# Noncompliant Weld Inspection Techniques

## Line 114 Non Destructive Examination Final Report

Issue Date December 5, 2013

**Figure 2 – Weld 270 Indication with measurement inset showing length of 0.157” (3.9mm)**

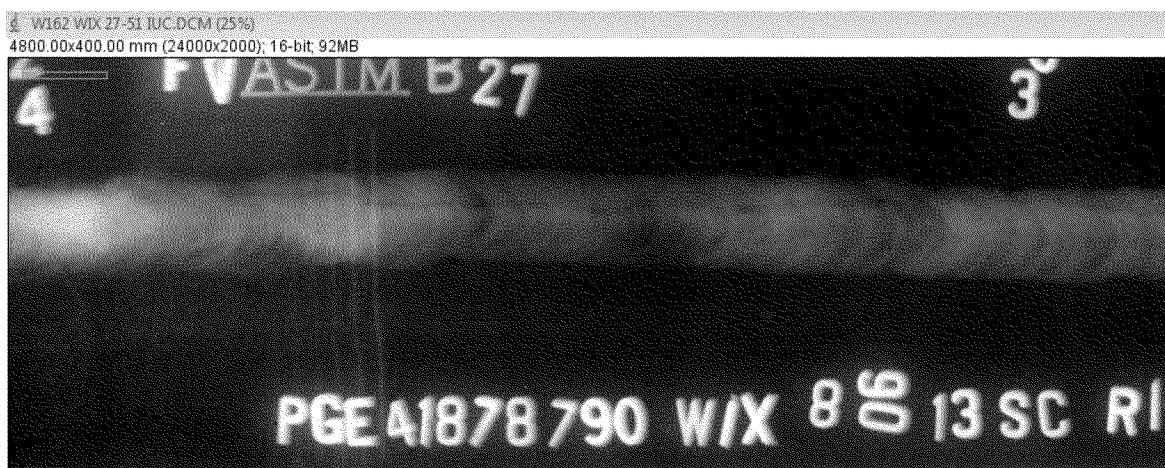
- 3.1 Weld 270, digitized in the region of interest is depicted in Figure 2. Here it can be seen, due to low change in density which is less than the adjacent parent material, and the presence of a halo, that the indication is one of Burn-Through (BT), and is acceptable per section 9.3.7 of API-1104. The weld repair process confirmed this result where the indication was found at the root.

**Figure 3 – Weld 311 with acceptable BT length of 0.141” and acceptable small pores**

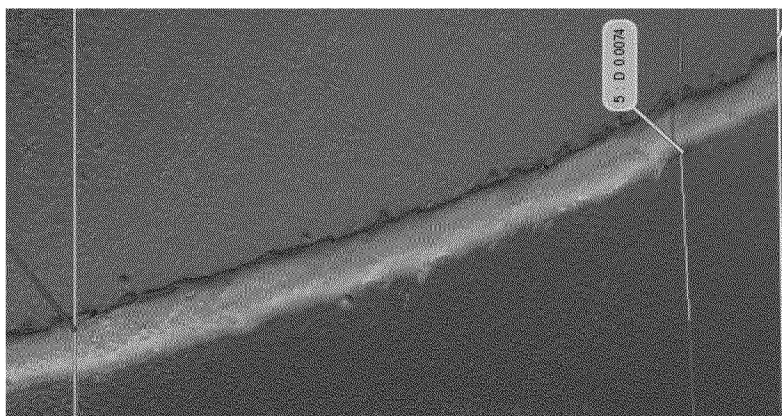
3.2 Weld 311, digitized in the region of interest, is depicted in Figure 3. Similarly we have one indication of burn-through and 3 small pores, all of which are acceptable per sections 9.3.7 & 9.3.9 of API 1104. For both welds 270 and 311, the repair process had to proceed to the root before the indications were eliminated, confirming that they were caused by burn through.

Figure 1 – Assessment of Weld 760 IUC region of interest

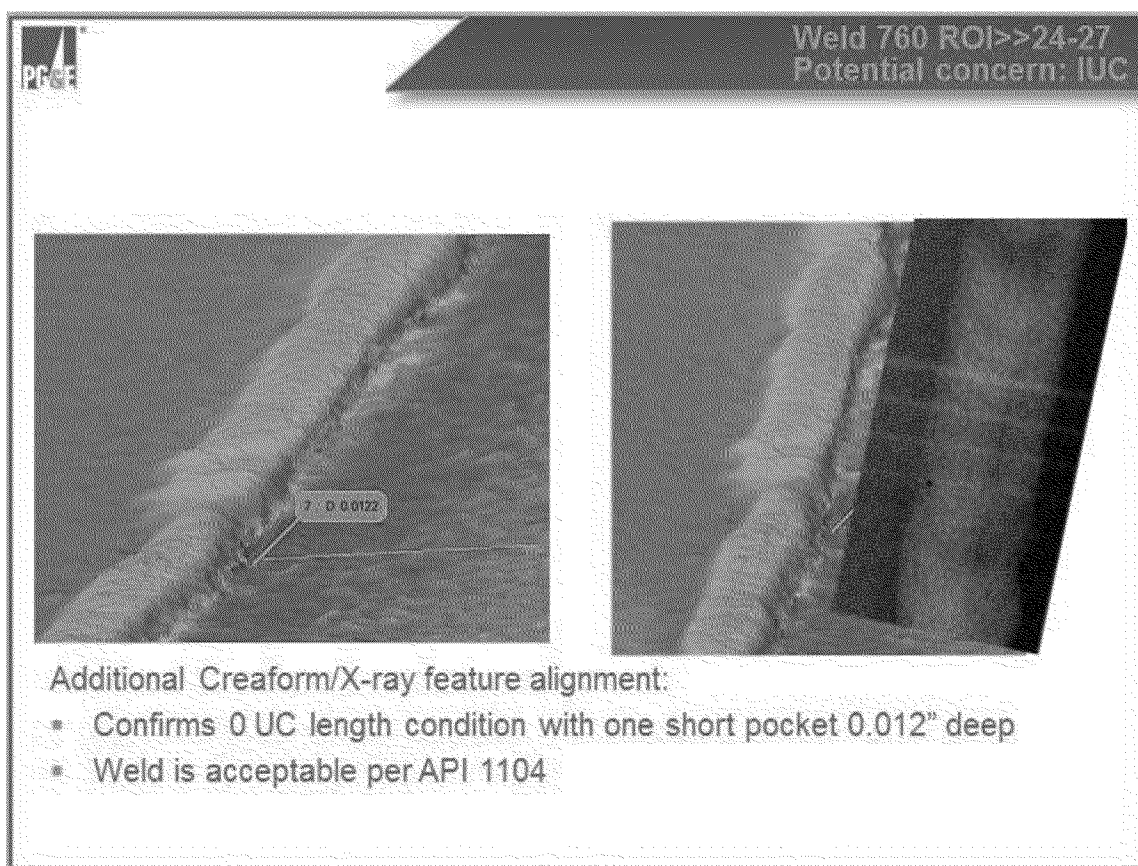
3.5 Creafom photogrammetry results were obtained for all the radiographic ROI's. The criteria applied to these results were API 1104 section 9.7, Table 4, "Maximum Dimensions of Undercutting". Applying the further criteria of depth from this requirement, to the documented radiographic and visual measurement data for length, all welds were found acceptable. Figure 2, from slide 5 in Appendix I, summarizes the typical physical condition for the audit identified indications of concern.

**Weld 760 cited for indications of internal undercut from 24-27**

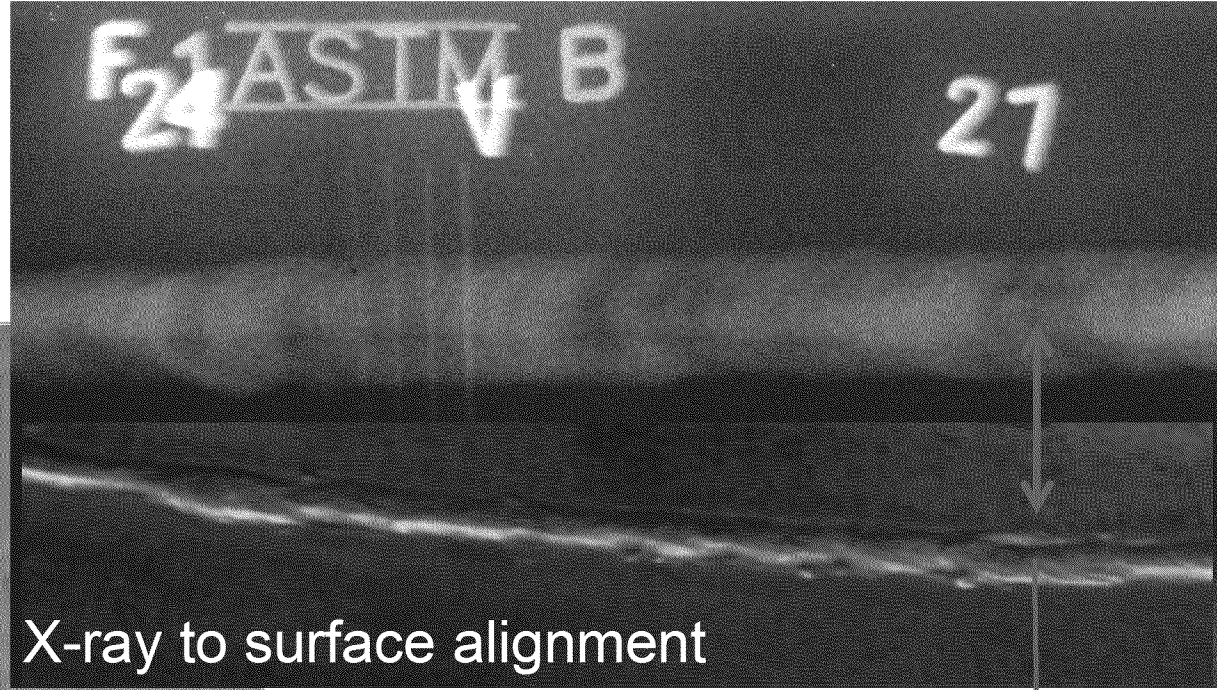
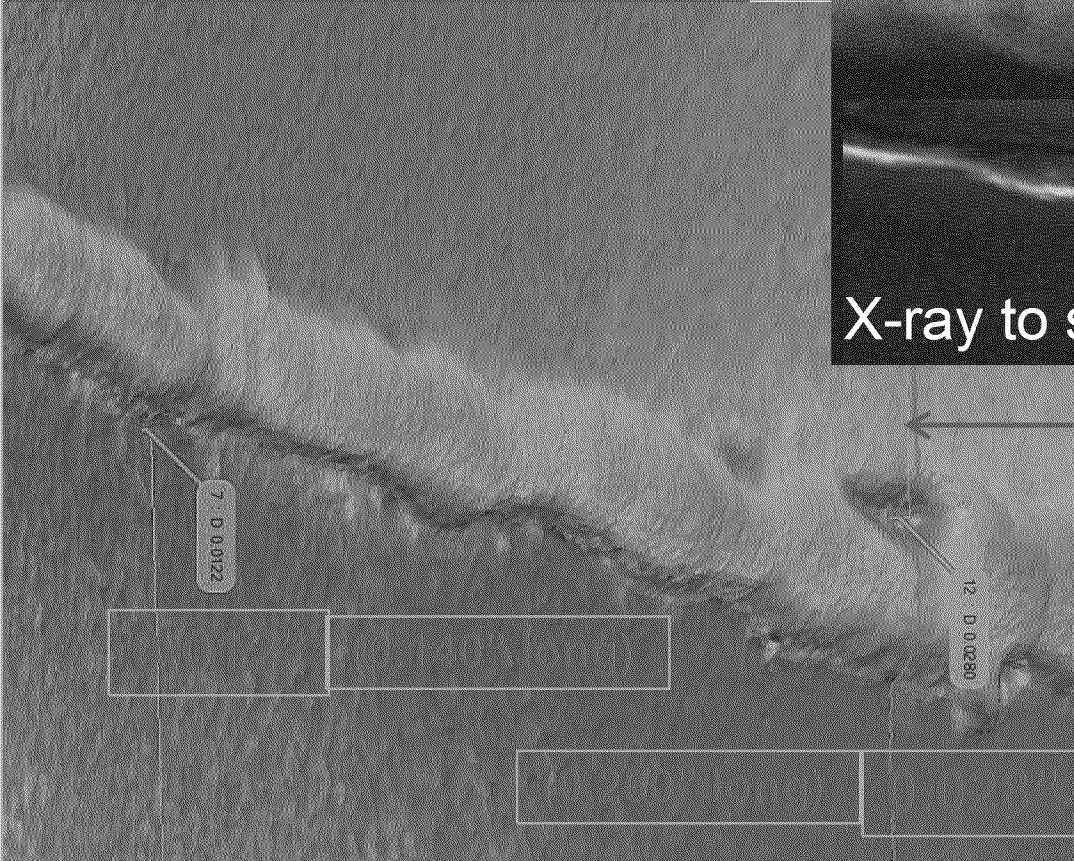
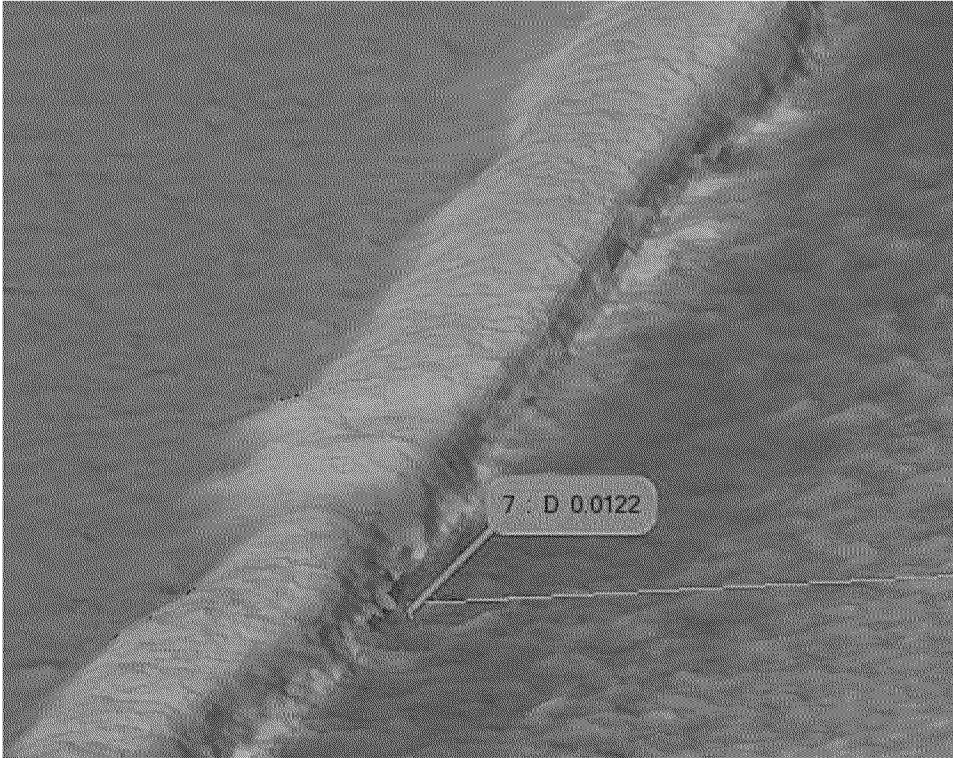
**Depth of most severe indications estimated by change in x-ray density**

**RT estimated depths of 0.012 – 0.028 inches**

Confirms indications are mostly diffraction effects on minor hi/lo condition with 0 UC

Two small pockets are 12 and 28 mils deep with greatest length of 0.250"

Weld is acceptable per API 1104

Weld 770 cited for indications of internal undercut from 36-42  
Excised weld photo-documented and ROI aligned with weld features  
Depth of most severe indications estimated by change in x-ray density

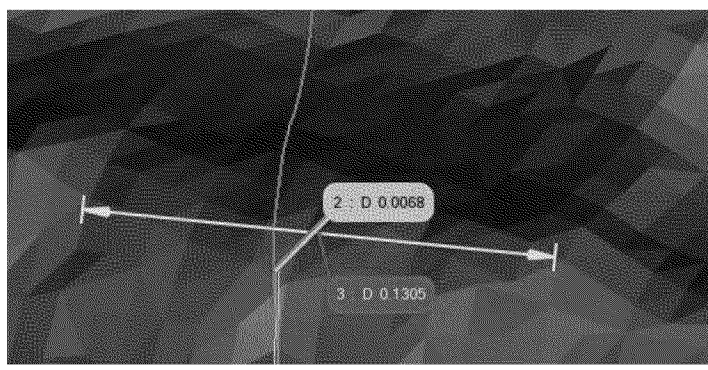
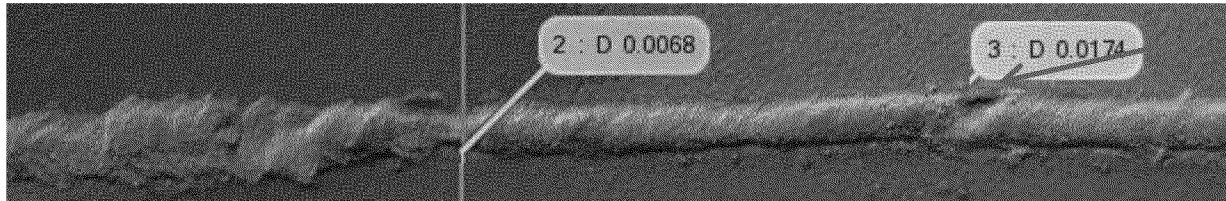
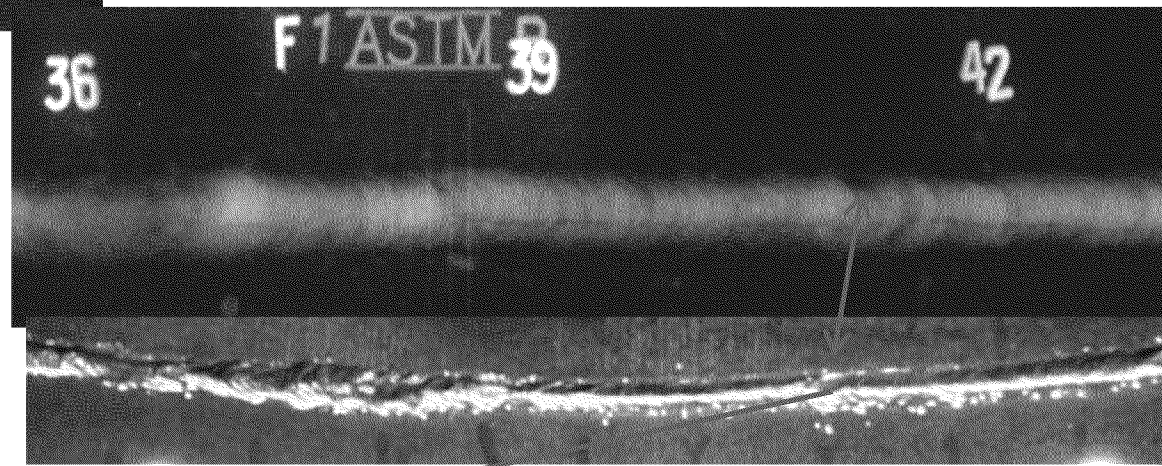
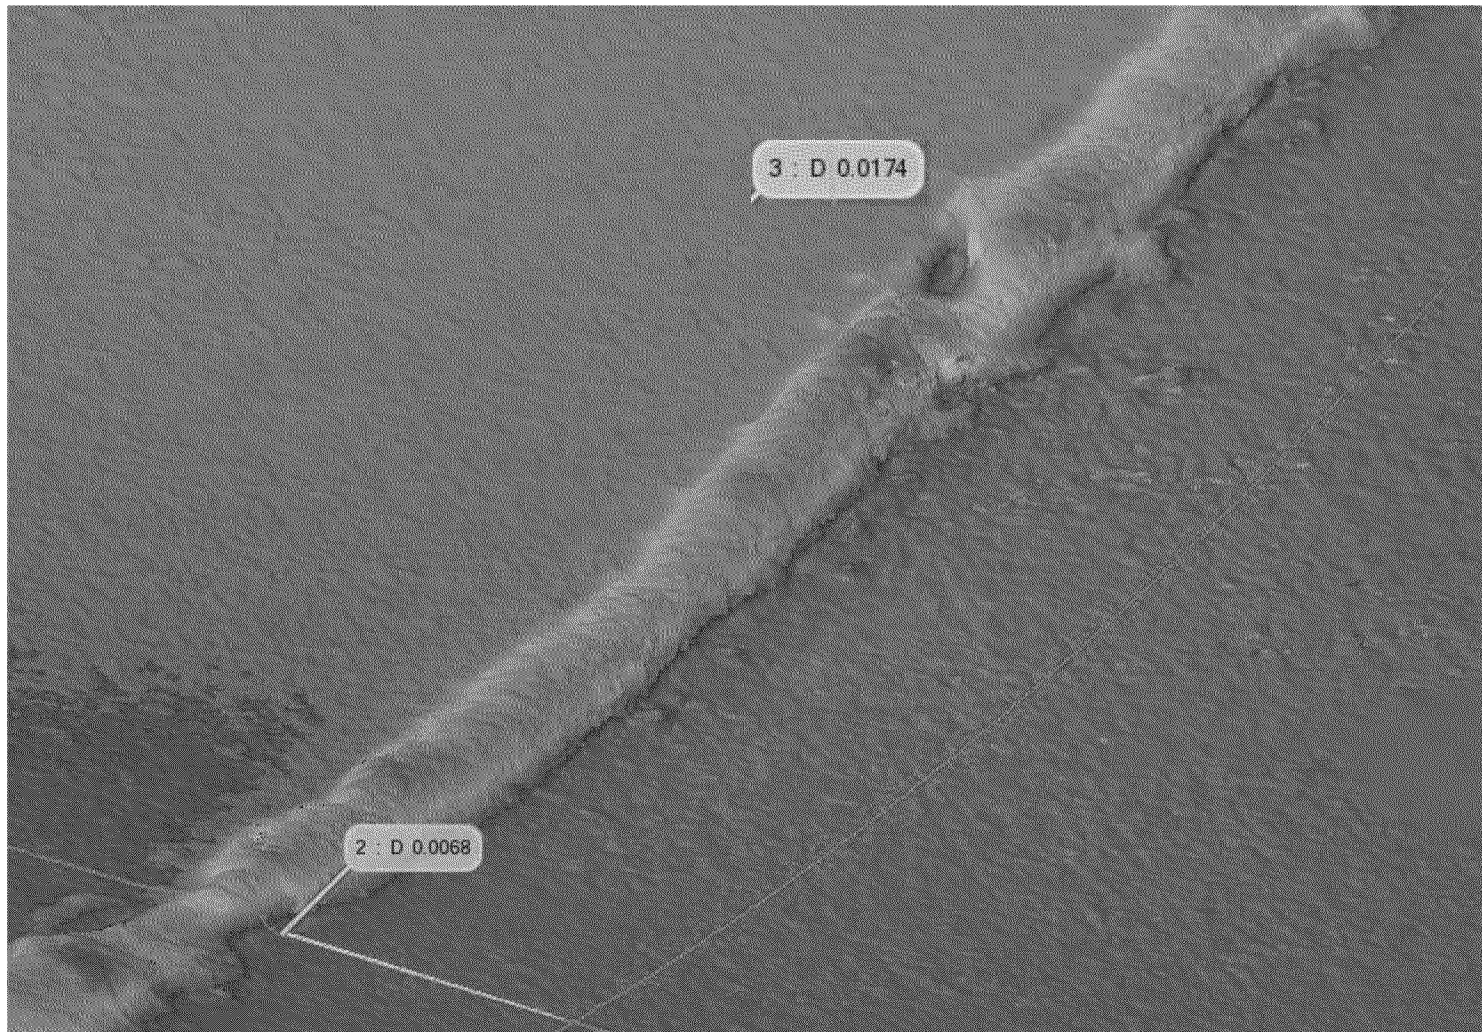
RT estimated depths of up to 0.008 inches

- Confirms indications are, in the majority, diffraction effects on minor hi/lo condition with 0 UC
- One small pocket observed at 0.007" deep x 0.130" long
- One unrelated pocket opposite ROI of 0.017" deep x 0.195" long
- Weld is acceptable per API 1104

Weld 771 cited for indications of internal undercut from 12-24

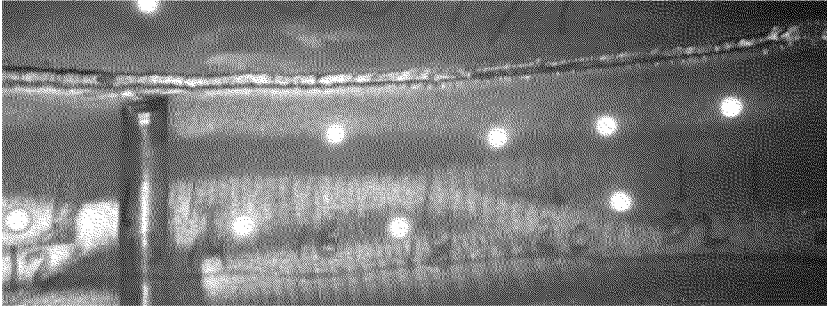
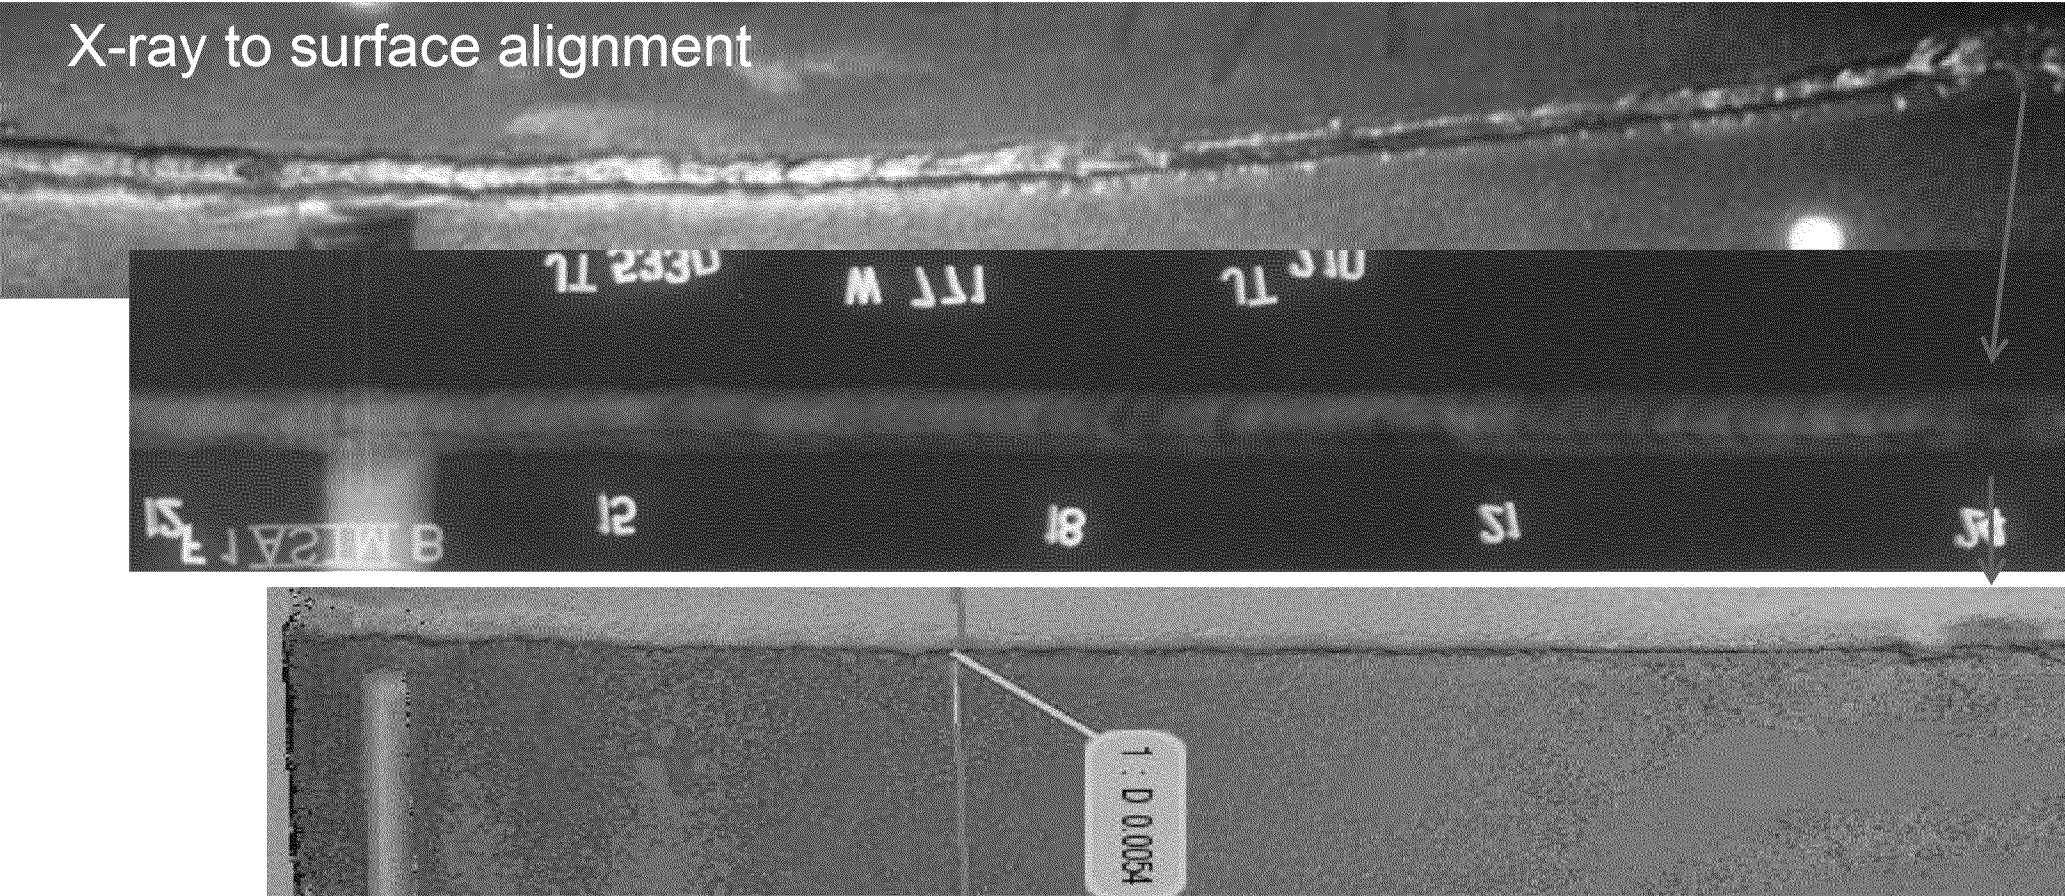
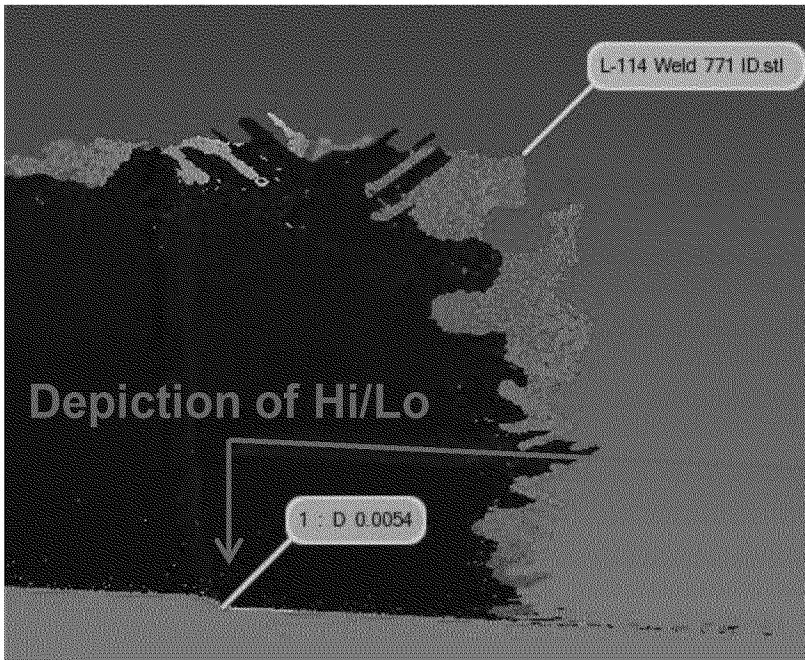
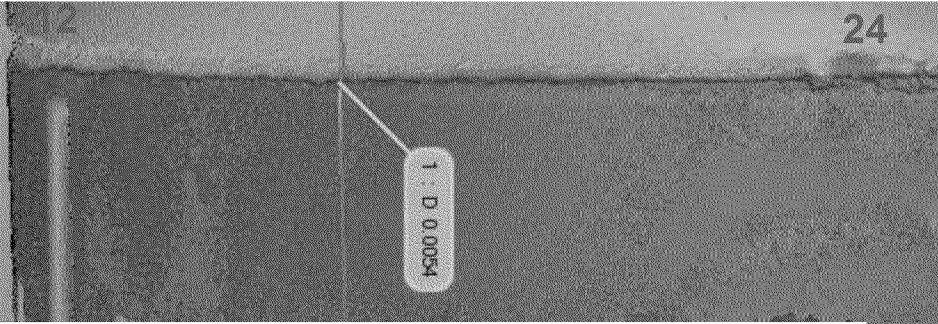
RT estimated depths of up to 0.008 inches

- Confirms indications are mostly diffraction effects on minor hi/lo condition with 0 UC
- Deepest region along length is 0.006 inches
- Weld is acceptable per API 1104
